This correspondence follows Commissioner Minute #2, issued on 28 May 2025, and continues the procedural matters raised in that minute.

PROJECT:
Rā Tuatahi No.1 10MWac

PROJECT
HORORATA SOLAR PANEL FARM

RC246059 Land Use Consent Conditions

Rā Tuatahi NO.1 - SOLAR POWER SCHEME SITE PLAN GENERAL ARRANGEMENT
SCALE: NTS

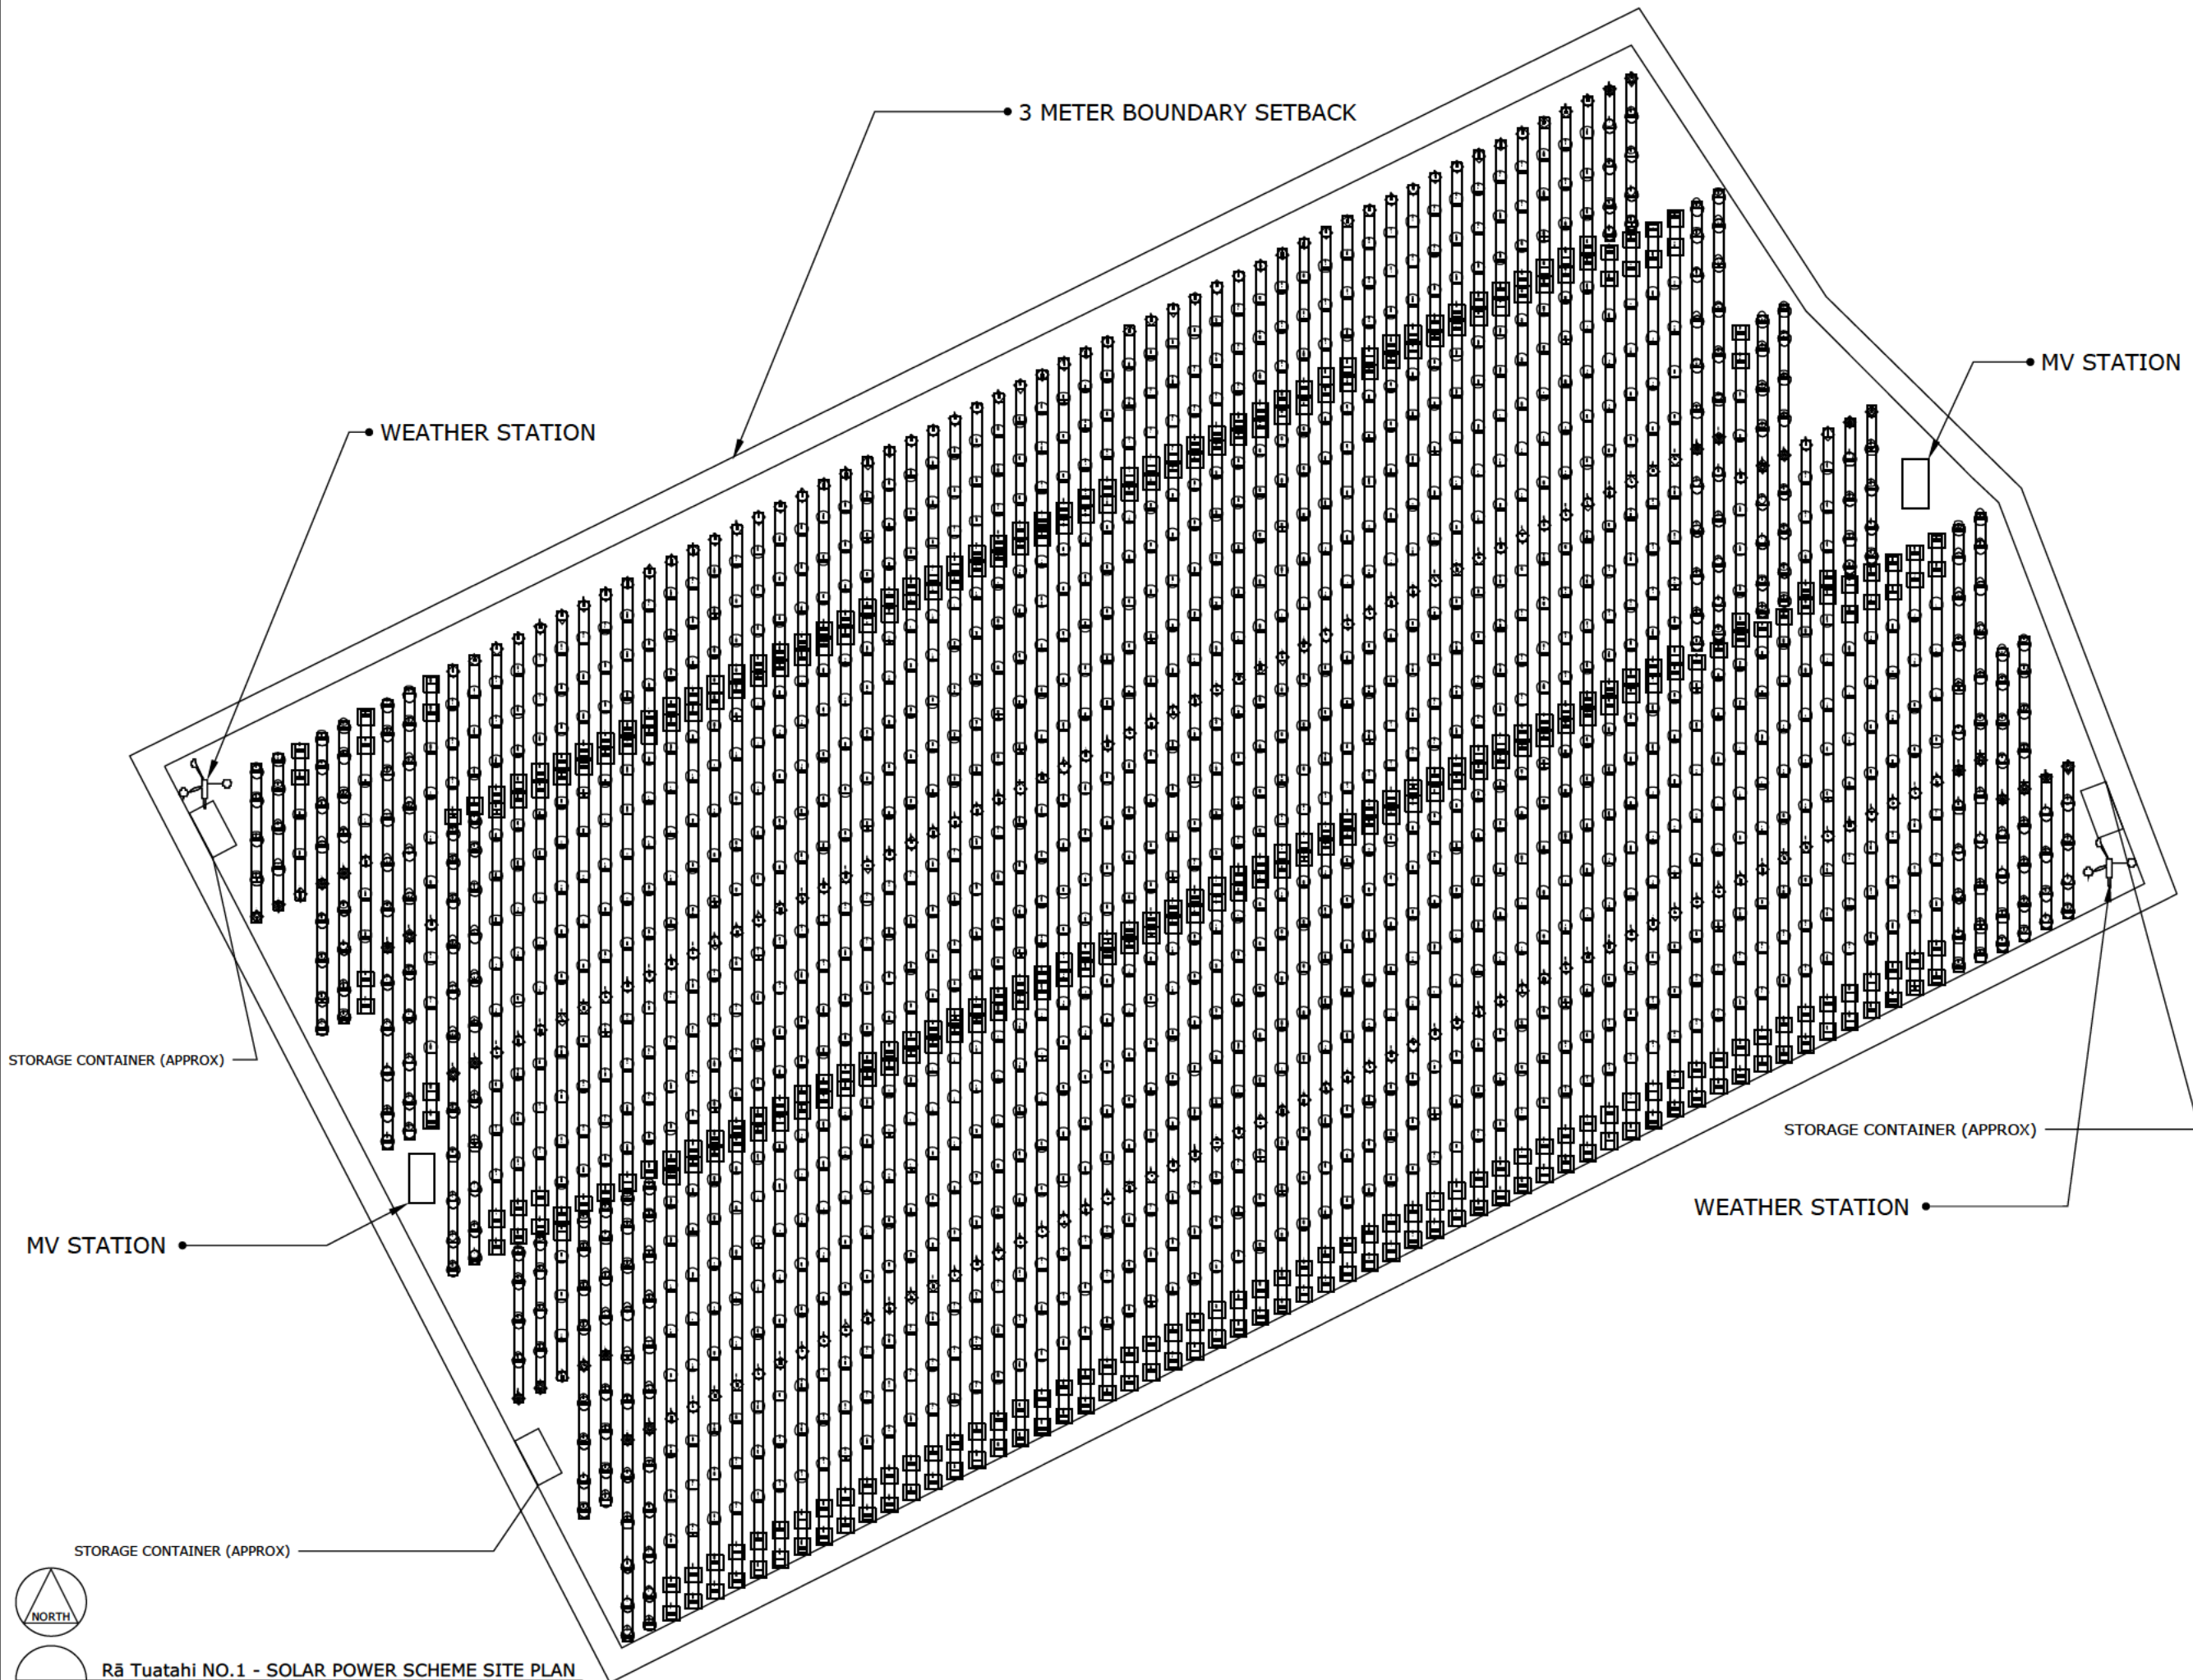
Accordingly, I direct that the Applicant provide an updated set of site and landscape plans which are wholly consistent with the proposed consent conditions they have agreed to, and which include clearly annotated setback dimensions.

LANDSCAPE PLAN

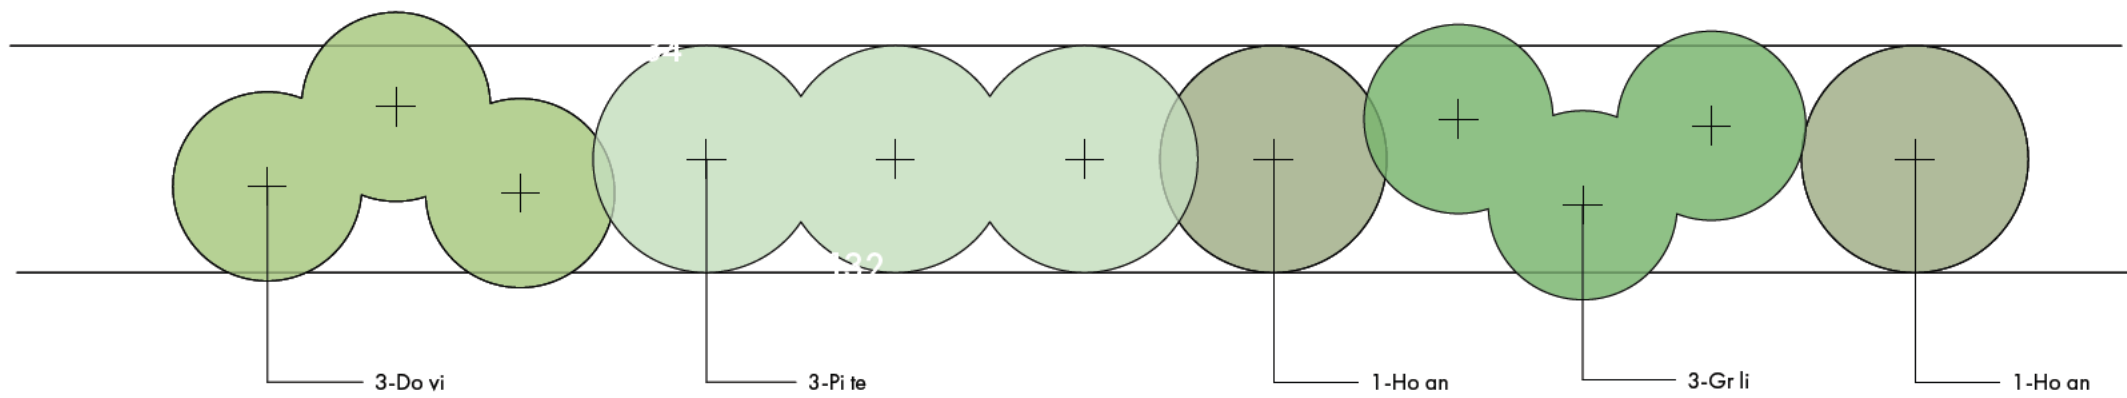
By way of example, the proposed conditions specify that no planting is to occur along the boundary shared with Lot 7 DP 66179 and Lot 3 DP 78682. Notwithstanding this, the current landscape plan shows planting along these two boundaries. In a further example, neither the site plan nor the landscape plan depicts the required four metre wide gravel firebreak along the full length of the boundary with Lot 2 DP 78682. The available plans also suggest that the proposed panels would be located within 10 metres of this boundary, despite the Applicant having agreed that all panels will be set back at least 10 metres. Inconsistencies of this nature between the proposed consent conditions and the submitted plans are significant and must be resolved to ensure clarity and enforceability, should I be minded to grant consent.

- a. Plant species shall be Leyland cypress 'Leighton Green'.
 - b. Planting shall be in a double offset row, with no gaps, and shall be set back at least three (3) metres from each boundary
